DATE: September 6, 2012
TO: Planning and Transportation Commission
FROM: Shaun Lacey, Assistant Planner
SUBJECT: STUDY SESSION FOR 12-D-07—715 ALTOS OAKS DRIVE

1. 10-D-01 – Palo Alto Medical Foundation – 715 Altos Oaks Drive

DATE: March 17, 2011
TO: Planning Commission
FROM: Shaun Lacey, Assistant Planner
SUBJECT: STUDY SESSION FOR 10-D-01—715 ALTOS OAKS DRIVE

DATE: September 2, 2010
TO: Planning Commission
FROM: Shaun Lacey, Assistant Planner
SUBJECT: 10-D-01—715 ALTOS OAKS DRIVE

APPENDIX A
715 ALTOS OAKS DRIVE PROJECT SITE PLAN

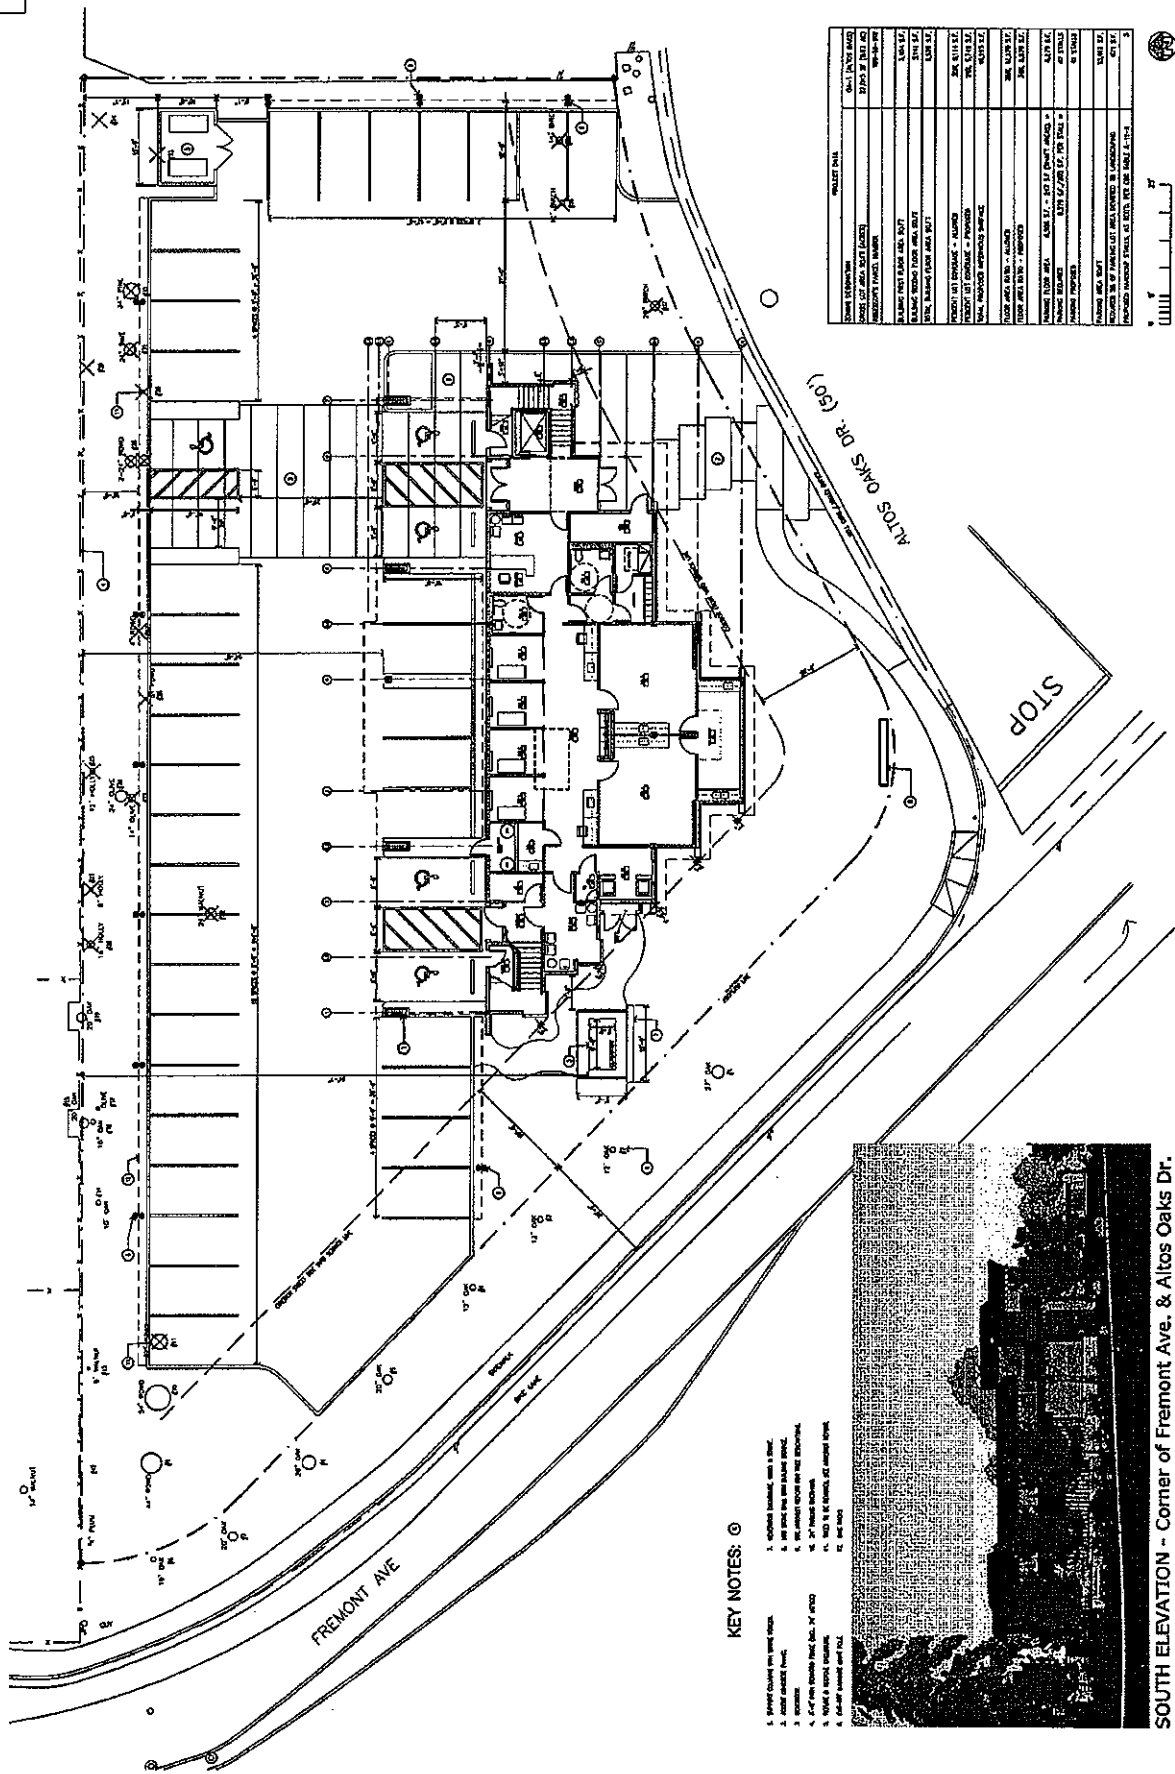
The site plan shows 42 parking spaces including five handicapped spaces; and hence the project site parking supply meets City code.
